Application for Works Approval

Works Approval Number	W6760/2022/1
Applicant	Round Oak Jaguar Pty Ltd
ACN	060 620 751
File number	DER2022/000546
Premises	Jaguar Operation – Tailings Storage Facility 3 Mining tenements M37/44, M37/1257 and M37/1153 LEONORA WA 6438
Date of report	23 March 2023
Decision	Works approval granted

Figure 3: Location of test pits and geological investigation boreholes

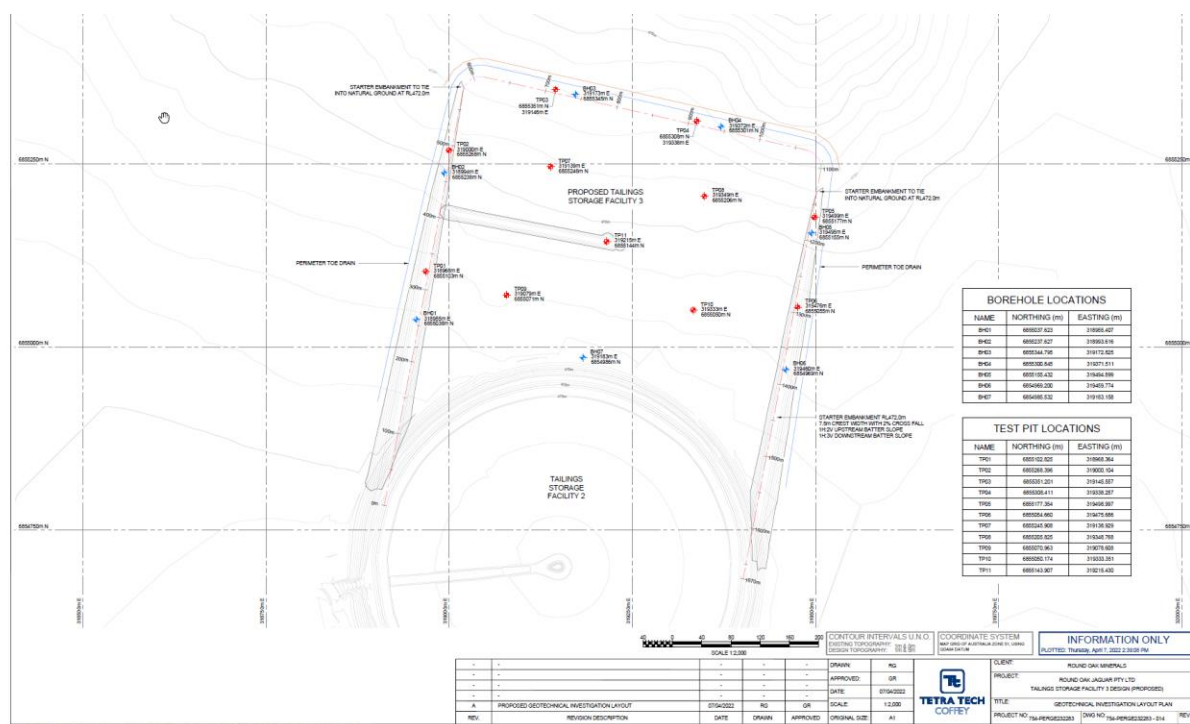
A duricrust (mostly ferricrete, some calcrete and silcrete) 2-3m thick is interpreted to underlie all or most of the TSF3 area, generally within 1m of the surface. This is based on boreholes and test pits shown in Figure 3. The only test pit which could be excavated beyond 1m before refusal was TP9, which is within the TSF3 basin not on the perimeter. If undisturbed, this duricrust is expected to be virtually impermeable. This position is supported by falling head tests on sampled material showing variously low permeability to practically impermeable.

The cut-off trench with a nominal depth of 1m below the embankment wall is expected in most areas to intercept the duricrust. In these sections, the cut off trench will be limited to the depth the construction equipment can scrape. Drill and blast will not be employed to extend the depth to 1m as the crust is low permeability and additional depth offers no additional seepage containment.

It is possible that in some areas, there may be a gap between the base of the cut off trench (1m below ground level) and the duricrust. This could allow lateral seepage that would sit on top of the duricrust and be accessible to vegetation. The applicant asserts that deepening of the cut-off trench to intercept the duricrust is not warranted due to the underdrainage system. A similar

Considering the compacted floor, underdrainage system and understanding that the cut-off trench is likely to intercept the duricrust for much of its length, the Delegated Officer considers that the likelihood of seepage causing stress or death of vegetation is **Unlikely**. This results in a risk rating of **Medium**.

- All stormwater upstream to be diverted away from the TSF3 (as stormwater from upstream catchments reporting to the TSF has not been accounted for in the water balance); and
- All boreholes within the TSF3 footprint to be grouted to prevent a direct path for seepage
